Item No. 8.1 (i)
Halifax Regional Council
August 16, 2011

SUBJECT: Project 00953: Wind Energy Facilities in HRM

SUPPLEMENTARY REPORT

Schedule A-1.1 - Wind Energy Map

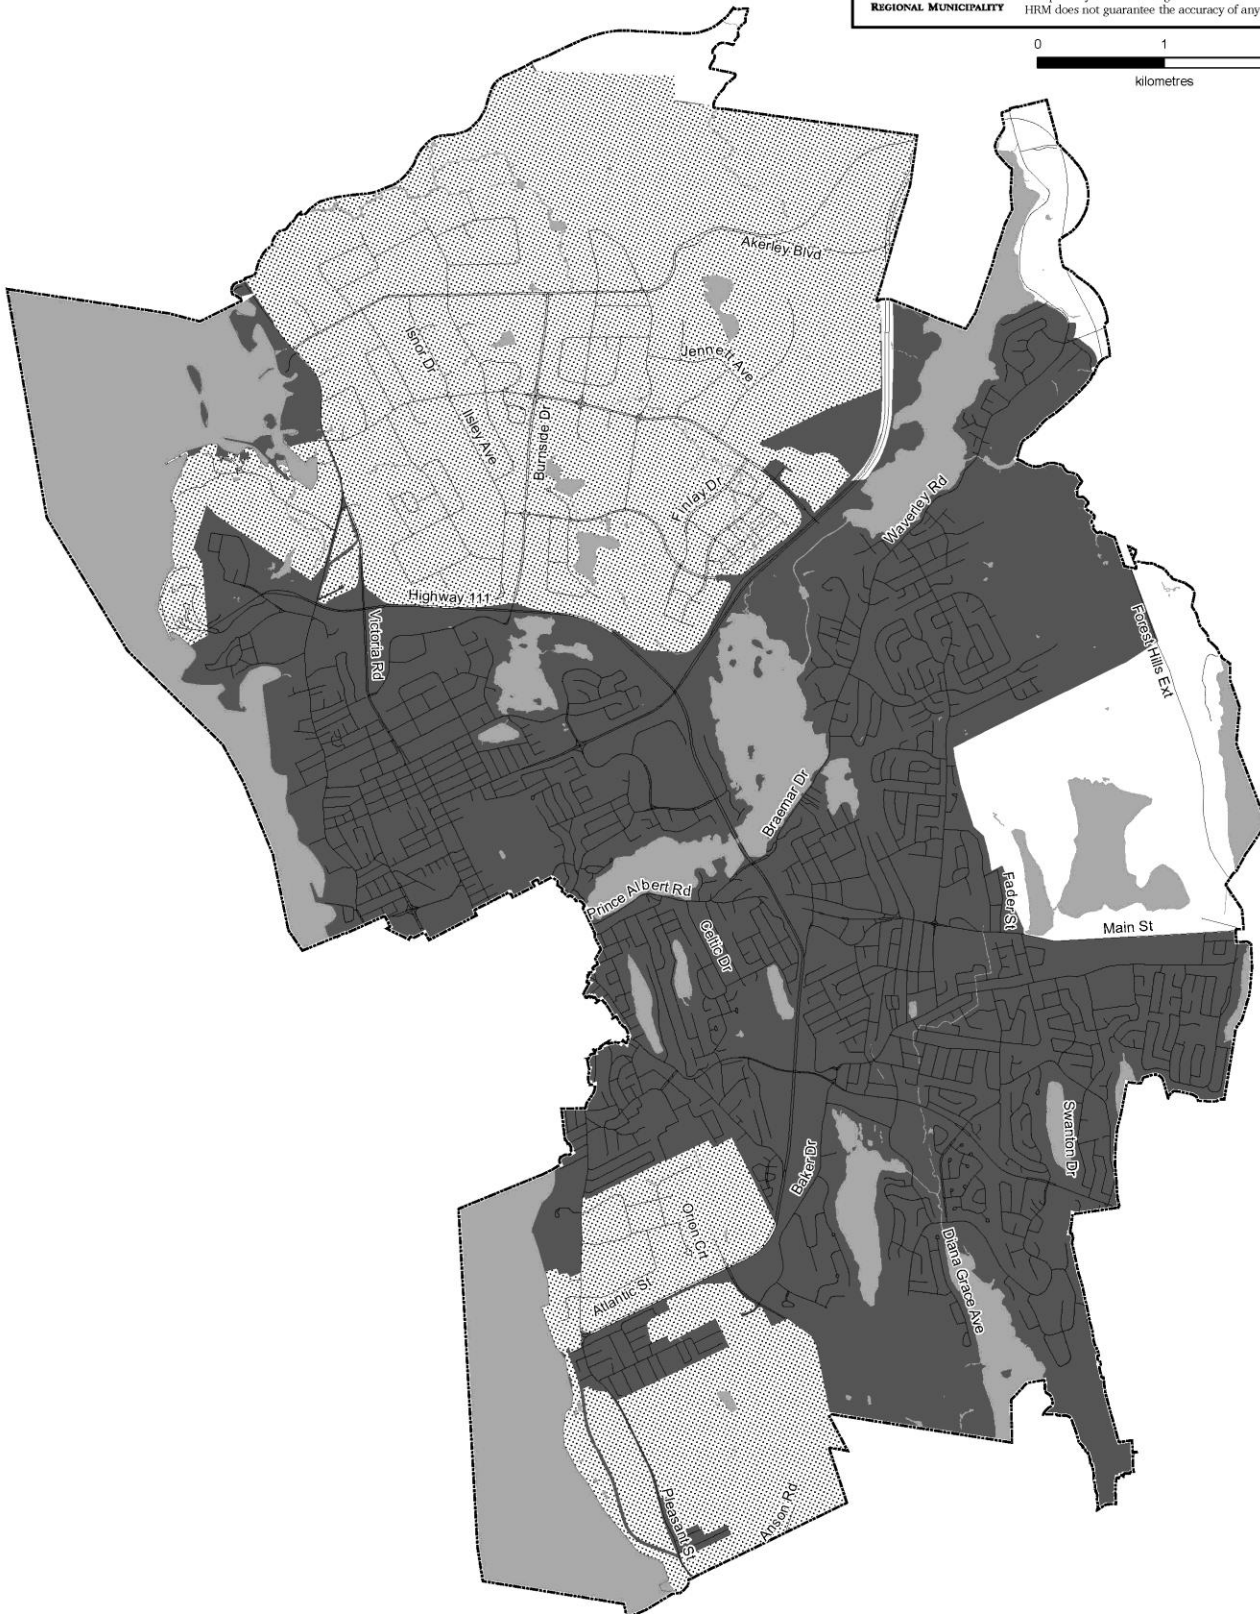
1. *Consider restricting as-of-right wind turbines from lands adjacent to Wright’s Cove to eliminate impacts to residential uses there.*

1. *Consider restricting as-of-right wind turbines from lands adjacent to Wright's Cove to eliminate impacts to residential uses there.*

1. ***That Regional Council restrict wind turbine development on properties adjacent to Wright's Cove that have residential development capability (LUB Map amendment).***

- 12) In Part IX SCHEDULES delete **a) Schedule - Map A-1 – Wind Energy Zoning Map** and replace with the following:
 - a) Schedule - Map A-1.1 – Wind Energy Zoning Map**
